## **REDLANDS SUBDIVISION, PHASE 2**

APPLICATION NUMBER 8 DATE April 5, 2018

APPLICANT Redlands Subdivision, Phase 2

REQUEST Subdivision

# DETAIL SITE PLAN

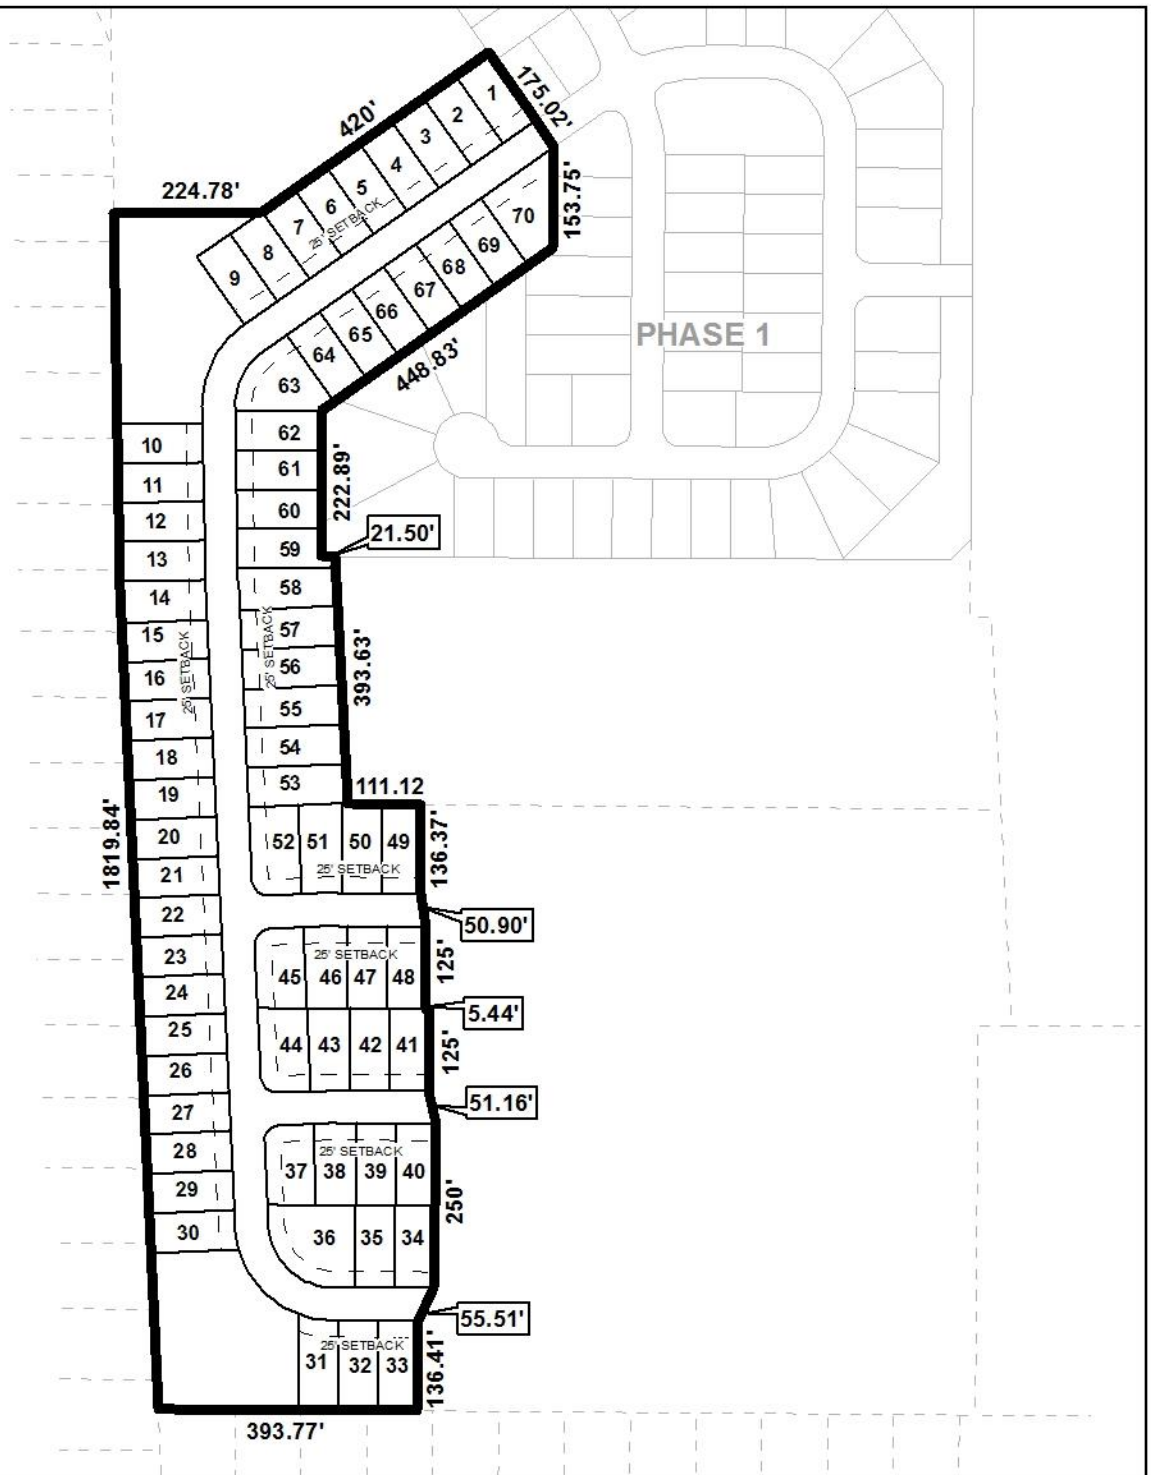
The plat illustrates the proposed 70 lot, 18.5 ± acre subdivision which is located adjacent to East side of Hunters Ridge West Subdivision, Unit 1, and the North side of Hunters Ridge Subdivision, 4<sup>th</sup> Unit, extending to the West side of proposed Redlands Subdivision, Phase 1, and is located within the Planning Jurisdiction. The applicant states that the subdivision is served by public water and sanitary sewer (South Alabama Utilities).

The purpose of this application is to create 70 legal lots of record from a portion of a lot proposed by the Alabama Pecan Subdivision, Phase 1, that was scheduled for the March 15<sup>th</sup> Planning Commission meeting. The application at hand would represent phase two of the Redlands Subdivision; the first phase was also scheduled for the March 15<sup>th</sup> planning Commission Planning meeting. Both Alabama Pecan Subdivision, Phase 1, and Redlands Subdivision, Phase 1, were heldover from the March 15<sup>th</sup> meeting to the April 5<sup>th</sup> meeting due to the lack of a quorum, however, both were recommended for holdover to the April 19<sup>th</sup> meeting due to concerns relating to the proposed extension of Eliza Jordan Road along the western banking of the overall site, as part of the Major Street Plan component of the Comprehensive Plan. Phase 1 of the Redlands Subdivision was additionally recommended for Holdover due to a lack of an overall plan for the entirety of the Redlands Subdivision, depicting all proposed phases. As no overall composite plan showing all proposed phases has been provided for the proposed Redlands Subdivision, staff has no information regarding the total number of phases, the ultimate number of proposed lots, nor the total number of access points for the subdivision.

Based on the preceding, the application is recommended for Holdover to the May 3<sup>rd</sup> meeting so that the following can be addressed:

- 1) an overall plan for the Redlands Subdivision, depicting all proposed phases, lots, and access points to be submitted by April 16<sup>th</sup> ; and
- 2) revision of the proposed subdivision to accommodate the proposed Eliza Jordan Road major street extension.
